## **MURRAY BRIGHAM PLACE SUBDIVISION**

APPLICATION NUMBER 16 DATE April 2, 2009

APPLICANT Murray Brigham Place Subdivision

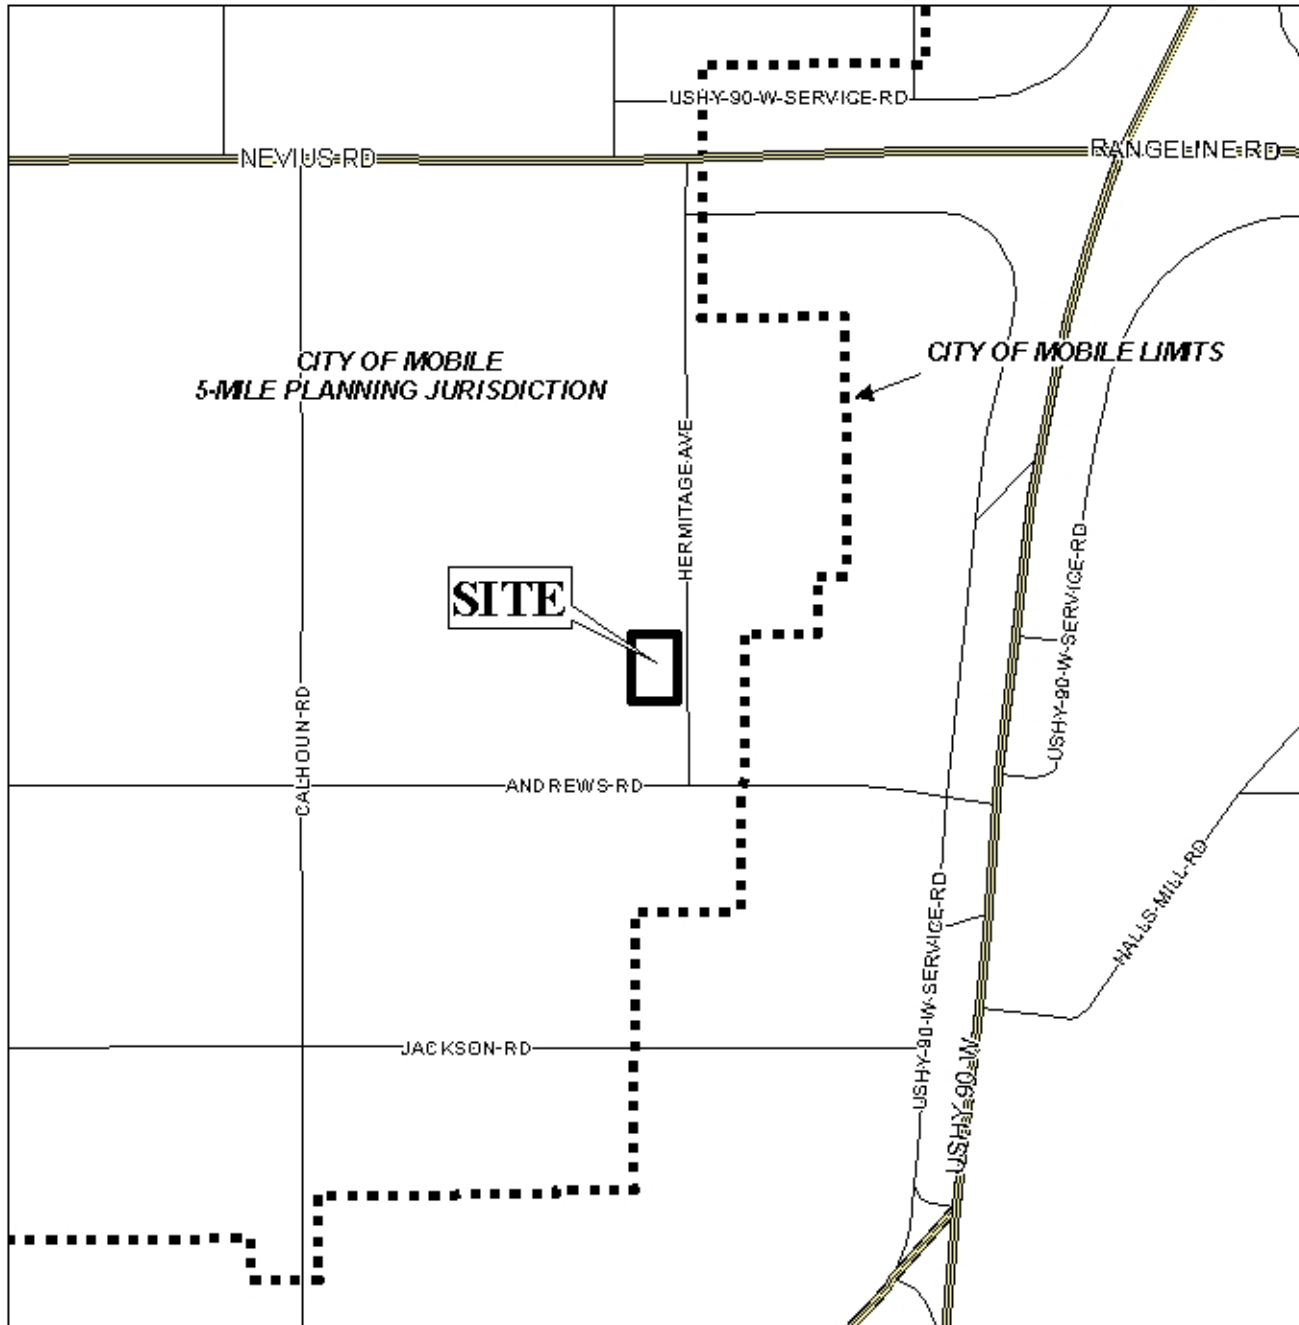
The plat illustrates the proposed 2-lot, 0.3± acre subdivision which is located on the West side of Hermitage Avenue, 150' North of Andrews Road. The subdivision is served by public water and public sanitary sewer.

The purpose of this subdivision is to create two legal lots of record from a metes and bounds parcel (South ½ of Lot 23 Block 2 of Suburban Gardens Subdivision) a portion of a legal lot of record. The applicant has not furnished the required deeds illustrating that the parceling off of a legal lot of record was before 1984 when the Subdivision regulations went into effect in the planning jurisdiction. However, the new lots will meet the minimum square footage requirement.

The site fronts Hermitage Avenue, which as illustrated has an existing 50-foot right-of-way. Hermitage Avenue appears not to be curb and gutter, therefore, a 60-foot right-of-way is required. It should be noted that the dedication of sufficient right-of-way to provide 30-feet from the centerline of Hermitage Avenue may reduce the overall square footage of each lot under the minimum square footage requirements of the Subdivision Regulations, the waiver of Section V.D.2. would be a favorable alternative since this is an established neighborhood. As a means of access management, each lot should be allowed one curb cut for each lot.

The site is located in the county. Therefore, a note should be placed on the final plat stating that any lots developed commercially and adjoin residentially developed property must provide a buffer, in compliance with Section V.A.7. of the Subdivision Regulations.

While the site is located in the county, compliance with the City of Mobile storm water and flood control ordinances will be required. A letter from a licensed engineer certifying compliance with the City's storm water and flood control ordinances should be submitted to the Mobile County Engineering Department and the Planning Section of Mobile Urban Development prior to the issuance of any permits.

- 1) the inclusion of the remainder of Lot 23 Block 2 of Suburban Gardens with the applicable labels and fees or the submission of the deed illustrating that the subdivision or parceling off was created prior to 1984;

- 2) provision of a note on the Final Plat stating that each lot is limited to one curb cut for each lot;
- 3) provision of a note on the Final Plat stating that any lots which are developed commercially and adjoin residentially developed property must provide a buffer, in compliance with Section V.A.7. of the Subdivision Regulations;

- 4) Placement of a note on the site plan stating that the site must be developed in compliance with all local, state and Federal regulations regarding endangered, threatened or otherwise protected species;

- 5) provision of a note on the Final Plat stating that the development will be designed to comply with the storm water detention and drainage facility requirements of the City of Mobile storm water and flood control ordinances, and requiring submission of certification from a licensed engineer certifying that the design complies with the storm water detention and drainage facility requirements of the City of Mobile storm water and flood control ordinances prior to the issuance of any permits. Certification is to be submitted to the Planning Section of Urban Development and County Engineering; and

- 6) labeling on the Final Plat of each lot in square feet, or provision of a table with the same information.
